**Falcon Eye Care**  
**7615 McLaughlin Road**  
**Peyton, CO 80831**  
 PROJECT NAME:  
 PROJECT ADDRESS:  
 PROJECT DESCRIPTION: LANDSCAPE PLAN

SHEET TITLE:  
**LANDSCAPE PLAN**

# Landscape Plan\_V1.pdf Markup Summary

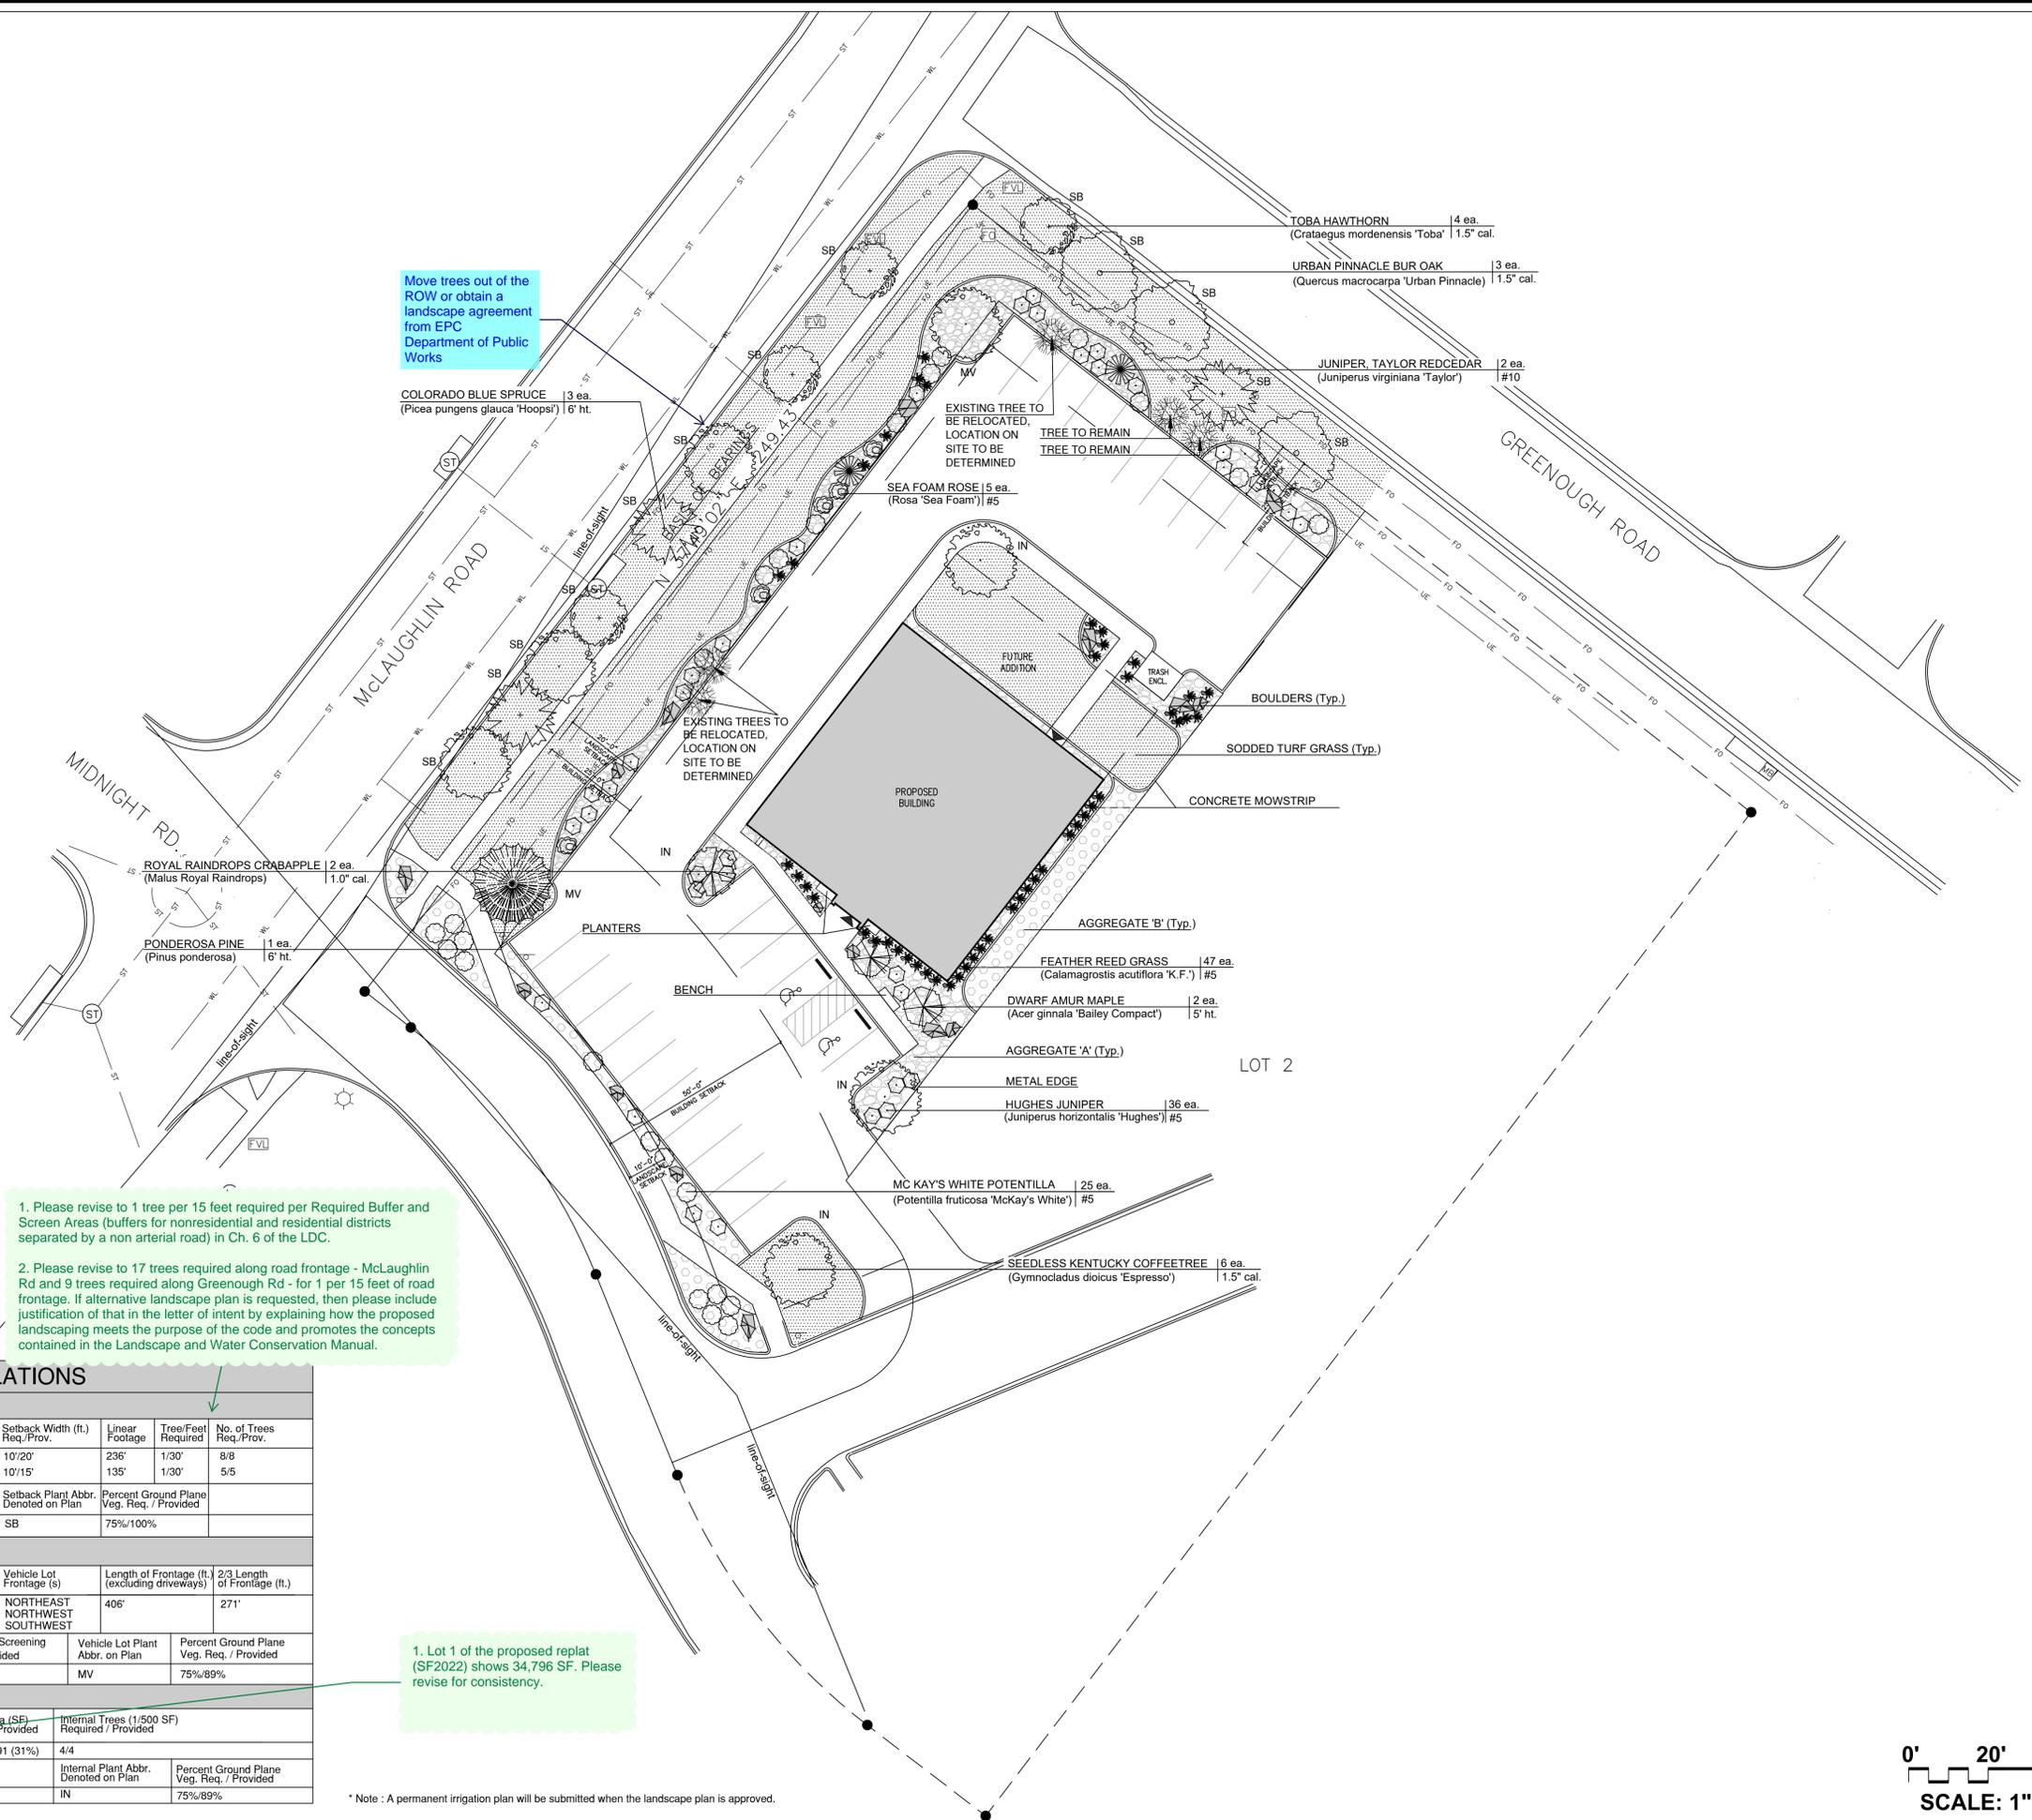
Move trees out of the ROW or obtain a landscape agreement from EPC Department of Public Works

Please note that landscaped areas (including no. of trees) within required landscape buffer areas, as well as parking areas, do not count toward internal landscaping requirement. Internal landscaping shall either be:  
 1. Adjacent to the building;  
 2. At all pedestrian entrances;  
 3. Within a plaza or courtyard;  
 4. In an area provided to separate building from parking lot; or  
 5. In a similar location which substantially conforms to the purpose of the required internal landscape area.

Please revise to 15-foot required per LDC Ch. 6 landscape buffer standards.

1. Please revise to 1 tree per 15 feet required per Required Buffer and Screen Areas (buffers for nonresidential and residential districts separated by a non arterial road) in Ch. 6 of the LDC.  
 2. Please revise to 17 trees required along road frontage - McLaughlin Rd and 9 trees required along Greenough Rd - for 1 per 15 feet of road frontage. If alternative landscape plan is requested, then please include justification of that in the letter of intent by explaining how the proposed landscaping meets the purpose of the code and promotes the concepts contained in the Landscape and Water Conservation Manual.

1. Lot 1 of the proposed replat (SF2022) shows 34,796 SF. Please revise for consistency.
